Intel[®] 82371EB (PIIX4E)

Specification Update

December 1999

Order Number: **290635-008**

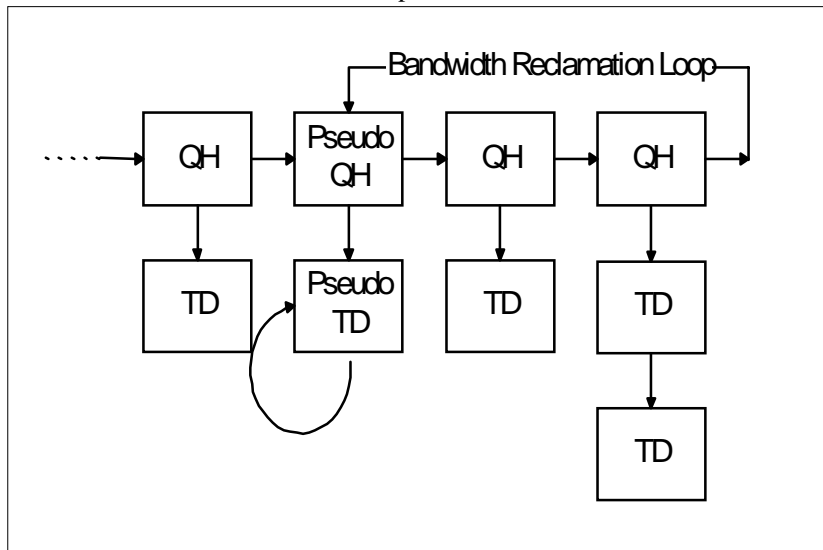
Workaround: When using bandwidth reclamation, the UHCI driver should insert a pseudo queue head with a pseudo transfer descriptor within the bandwidth reclamation loop. The PIIX4 will fetch this queue head and transfer descriptor on every frame, but will not transfer any data and will never be terminated. The following bits must be properly set to implement the workaround:

TD CONTROL AND STATUS (DWORD 1: 04-07h)

The Active status bit (bit 23) must be left unset at 0 indicating that the PIIX4 should not execute this TD.

QUEUE HEAD LINK POINTER (DWORD 0: 00-03h)

The Queue Head Link Pointer (QHLP=bits [31:4]) must be set to point to the pseudo TD.

The QH/TD Select (Q=bit 1) must be set to 1 indicating it is a QH.

The Terminate bit (T=bit 0) must be set to 0 indicating that the link pointer field points to a valid TD.
